GARRETT ESTATES SUBDIVISION

APPLICATION NUMBER 12 DATE June 17, 2004

GARRETT ESTATES SUBDIVISION

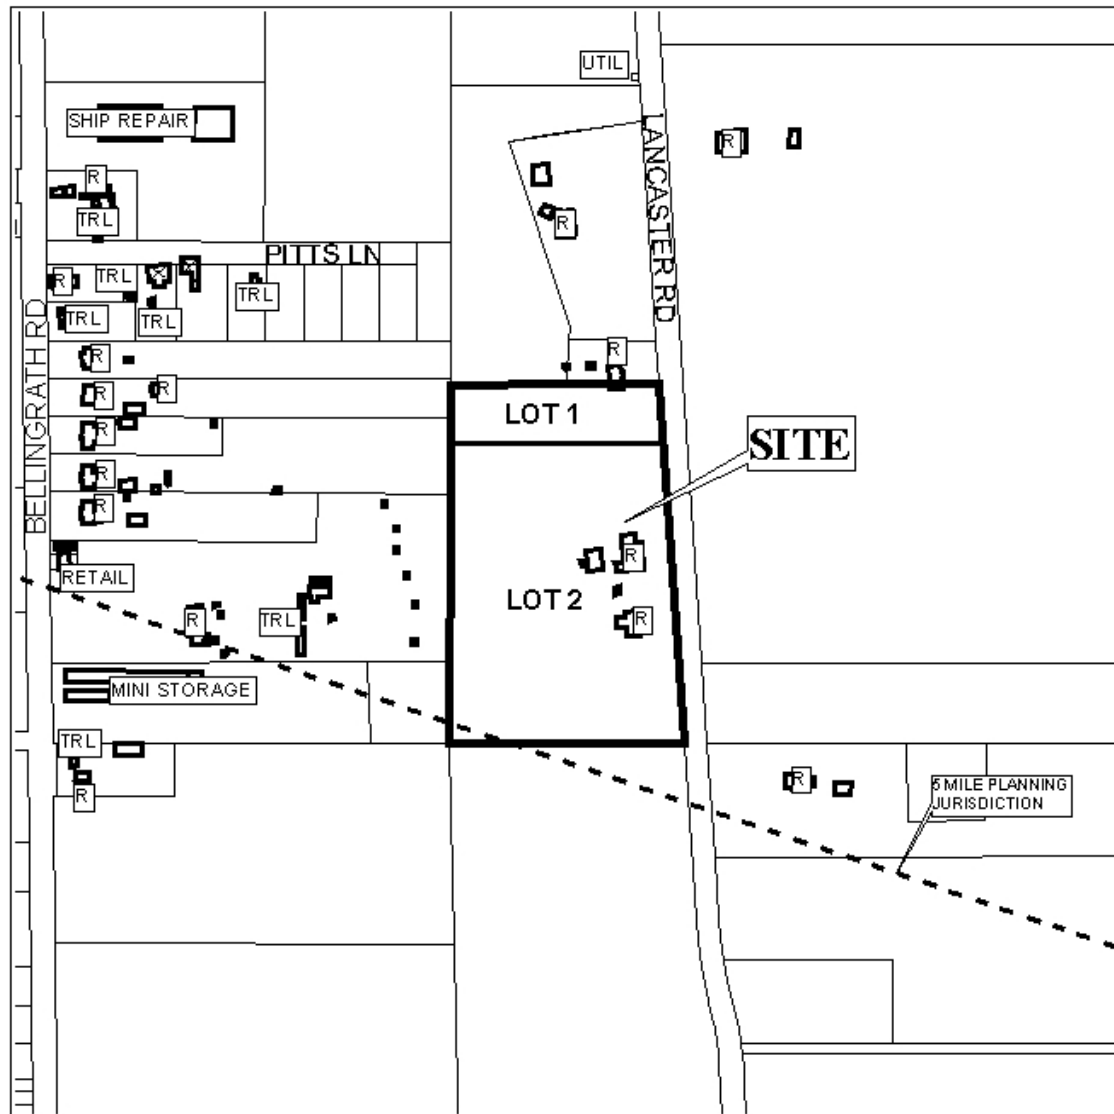
Lot 1 exceeds the maximum width to depth ratio as recommended by the Subdivision Regulations; therefore, a waiver of Section V.D.3., would be required.

This site is located in the County, thus a note should be placed on the final plat stating that any lots which are developed commercially and adjoin residentially developed property must provide a buffer, in compliance with Section V.A.7. of the Subdivision Regulations.

The 25-foot minimum building setback lines are not shown but would be required on the final plat.

With a waiver of Section V.D.3. (width to depth ratio), the plat will meet the minimum requirements of the Subdivision Regulations and is recommended for Tentative Approval subject to the following conditions: 1) the placement of a note on the final plat stating that any lots which are developed commercially and adjoin residentially developed property must provide a buffer, in compliance with Section V.A.7. of the Subdivision Regulations; and 2) the placement of the 25-foot minimum setback lines on the final plat.
